**SUBDIVISION STAFF REPORT** Date: June 3, 2004

**DEVELOPMENT NAME** McCrary Subdivision

**LOCATION** 4007, 4051 and 4057 Moffett Road

REQUEST Planned Unit Development and Subdivision

# SITE PLAN

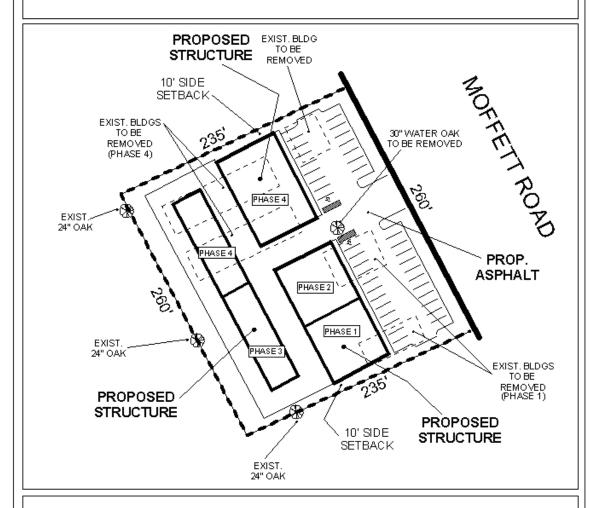
The applicant proposes to redevelop an existing site and as illustrated on the site plan, redevelopment will occur in phases. The front two buildings will consist of office(s) and retail, and the rear building will contain personal storage units. The site is zoned B-3, Community Business and the proposed uses are allowed by right in a B-3 district.

Based upon the proposed uses, a minimum of 42 parking spaces are required. The site plan illustrates the provision of 42 parking spaces, as required. The applicant should note however that based upon the parking, no restaurant or bar would be allowed in any of the tenant spaces. Furthermore, the site adjoins residential zoning to the West and South; therefore, the provision of a buffer, in compliance with Section IV.D.1. would be required where the site adjoins residential zoning.

Upon the completion of the fourth phase the site will consist entirely of new development, thus full compliance with the landscaping and tree planting requirements of the Ordinance is required. However, with phased construction, the provision of frontage trees should be required prior to the issuance of a Certificate of Occupancy (CO) for phase one. Additionally, full compliance with the landscaping and tree planting requirements of the Ordinance will be required prior to the issuance of a CO for phase four.

The site fronts Moffett Road, a planned major street, which has an existing right-of-way in compliance with the Major Street Plan. However, as a major street, access management is a concern, thus limiting the site to one curb cut, with the location and design to be approved by Traffic Engineering, would be appropriate. Additionally, Moffett Road is a federal highway; therefore, the approval of the Alabama Department of Transportation (ALDOT) will also be required for the proposed curb cut.

**RECOMMENDATION** Planned Unit Development based upon the preceding, this application is recommended for approval subject to the following conditions: 1) the provision of frontage trees prior to the issuance of a Certificate of Occupancy for phase one; 2) full compliance with the landscaping and tree planting requirements prior to the issuance of a Certificate of Occupancy for phase four; 3) the provision of a buffer, in compliance with Section IV.D.1. where the site adjoins residential zoning; 4) the approval of Traffic Engineering and ALDOT for the one curb cut to the site; 5) the provision of marked lane division and usage for driveway; 6) the provision of a sidewalk; and 7) full compliance with all municipal codes and ordinances.

**Subdivision** the plat meets the minimum of the Subdivision Regulations and is recommended for Tentative Approval subject to the following conditions: 1) placement of a note on the final plat stating that the site is limited to one curb cut to Moffett Road, with the location and design to be approved by Traffic Engineering and ALDOT; and 2) provision of a sidewalk.
